City of Detroit  
Inter-Departmental Communication

**RE:** Petition No. 618  
Requested Encroachment Into Cass, W. Lafayette, And Washington Blvd. In The  
Block Bound By Fort, Washington Blvd., Cass, And W. Lafayette

## **PROVISIONS FOR ENCROACHMENT For Petition 618**

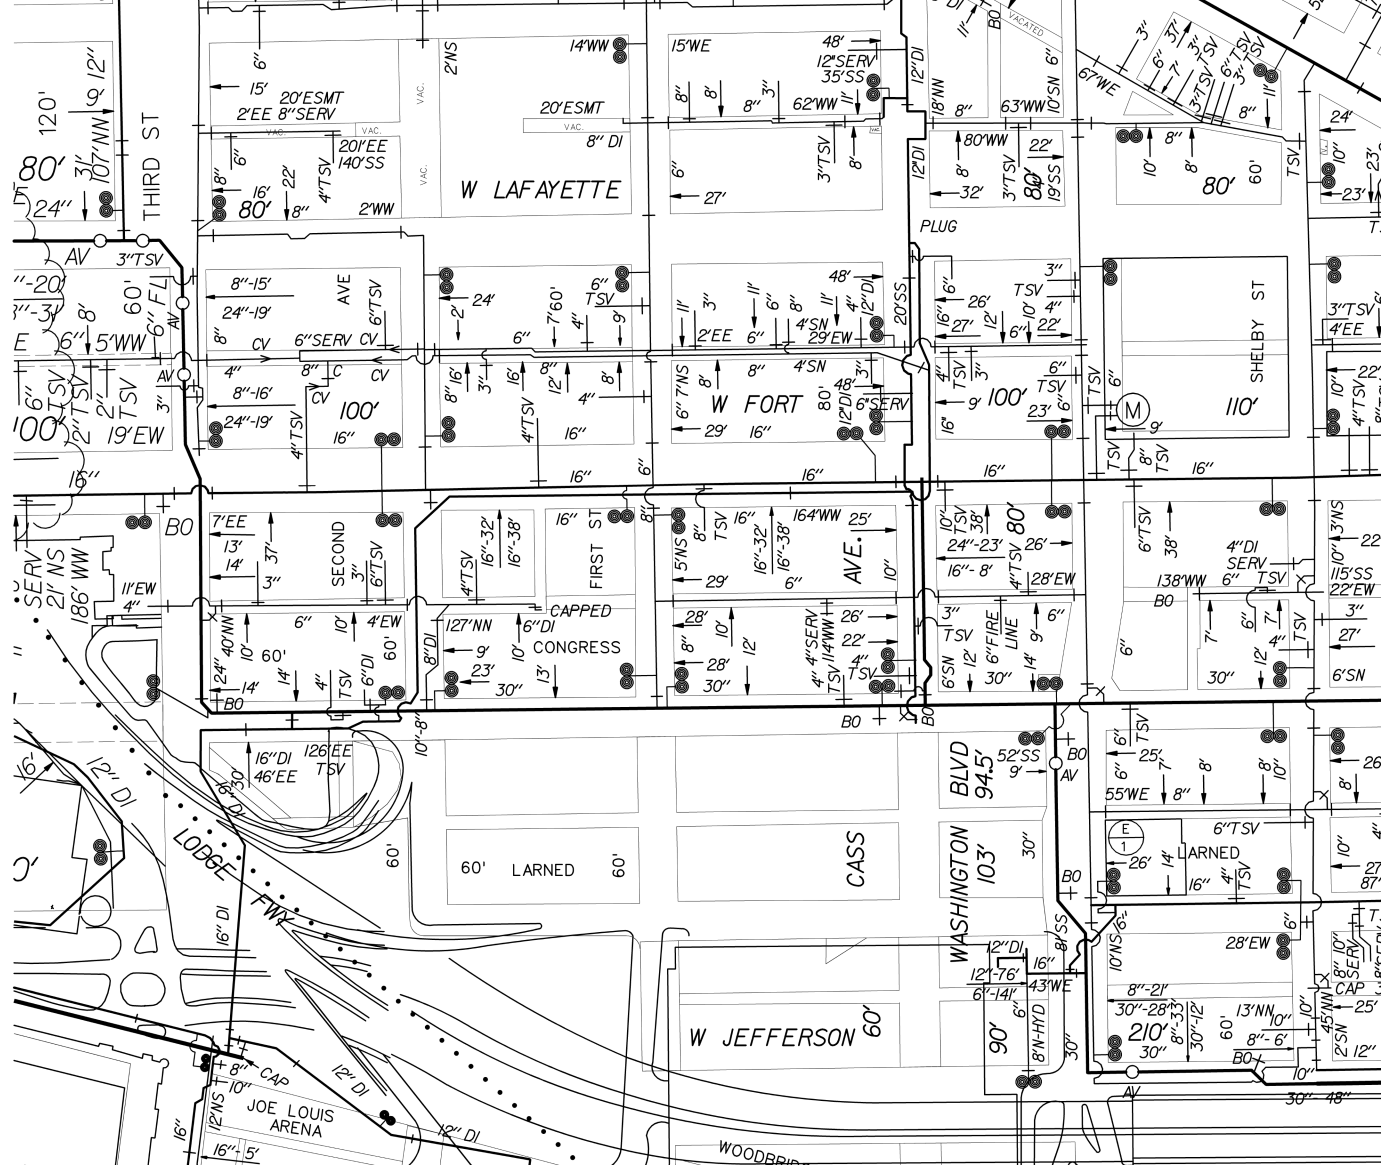
- Our records indicate that there are water mains and sewers in the area of encroachments. DWSD has no objections to the requested encroachments provided that the attached Provisions for Encroachment are strictly followed.

1. By approval of this petition the (DWSD) does not waive any of its rights to its facilities located in the right of way, and at all time, DWSD, its agents or employees, shall have the right to enter upon the right of way to maintain, repair, alter, service, inspect, or install its facilities. All costs incident to the damaging, dismantling, demolishing, removal and replacement of structures or other improvements herein permitted and incurred in gaining access to DWSD's facilities for maintenance, repairing, alteration, servicing or inspection caused by the encroachment shall be borne by the petitioner. All costs associated with gaining access to DWSD's facilities, which could normally be expected had the petitioner not encroached into the right of way shall be borne by DWSD.

2. DWSD requires a vertical clearance of 18 feet above grade for maintenance excess and repair.
3. All construction performed under this petition shall not be commenced until after five (5) days written notice to DWSD. Seventy-two (72) hours notice shall also be provided in accordance with P.A. 53 1974, as amended, utilizing the MISS DIG one call system.

4. Construction under this petition is subject to inspection and approval by DWSD forces. The cost of such inspection shall, at the discretion of DWSD, be borne by the petitioner.
